# **Sydney Construction Materials**

## **Newnes Junction Sand and Kaolin Extraction Proposal**

**Additional information as requested during meeting  
with DIPNR, 23<sup>rd</sup> February, 2005**

**March 2005**

Figure 12 - Graphic Logs from Drill Holes and Measured sections on the Newnes Plateau (Pecover 1986)

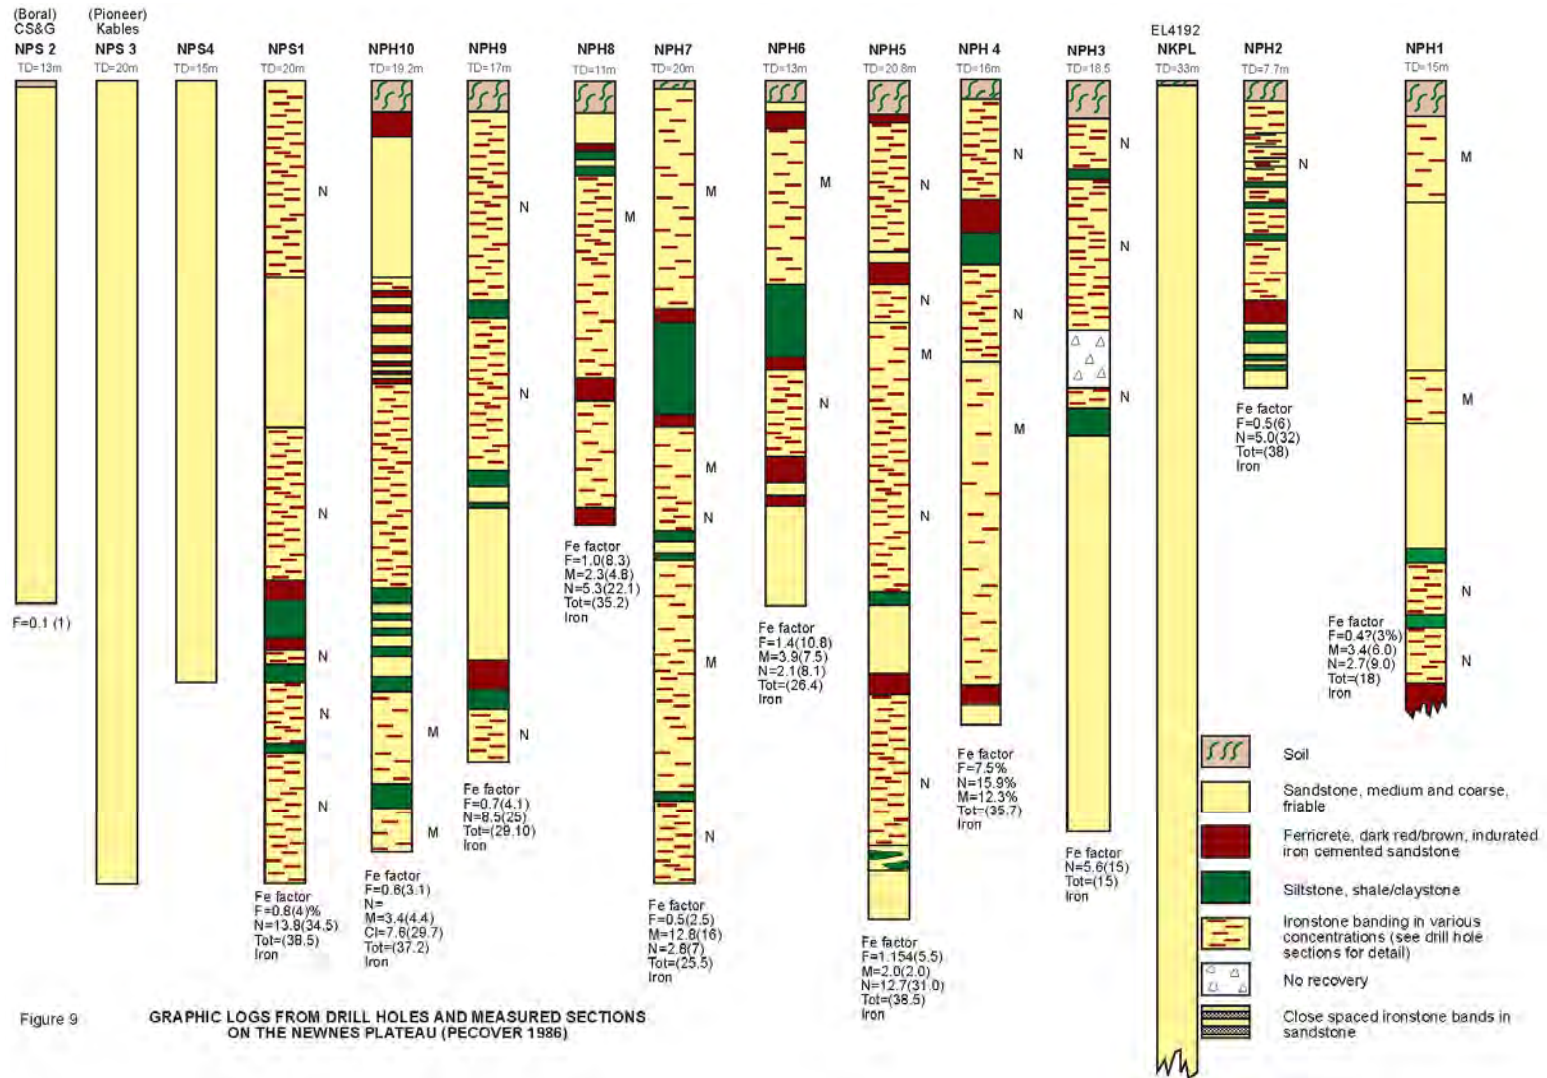
| Issue # | Issue Summary  |
|---------|--|
| 6       | No explanation of "iron factor" or how it was determined.  |

Quantification of ironstone (ferricrete) occurrences within regional drill holes over the Newnes Plateau (Pecover 1986) has been achieved by assigning a conversion factor for each of the drill log terminologies of Pecover (1986). The values assigned are subjective, however when applied to each of the eleven drill holes and measured sections it provides us with the relative means of comparison of ironstone values over the Newnes Plateau – see Figure 12 below. Figure 12 contains graphical logs from drill holes and measured sections at various locations on the Newnes Plateau (Pecover, 1986) showing the distribution of ferricrete densities and the calculated iron factors. The conversion table used follows below:

When calculating the iron factor in a particular drill hole, the thickness of ironstone (ferricrete) in each of the logged intervals is calculated back as an adjusted thickness. For example, for a 6m interval logged as friable sandstone with numerous bands of ferricrete, the calculated thickness of ferricrete is 50% x 6m = 3m. The final iron factor is the percentage of total ferricrete thickness over the entire drilled section.

Measured section NPS1 of Pecover (1986) (4<sup>th</sup> sample, Figure 12 below) yielded an iron factor of 38.5. When recalculated with probable values (see previous table), the iron factor is 18. As all iron factor values are calculated on the same scale the results are relative and there is no difference to the final interpretations.
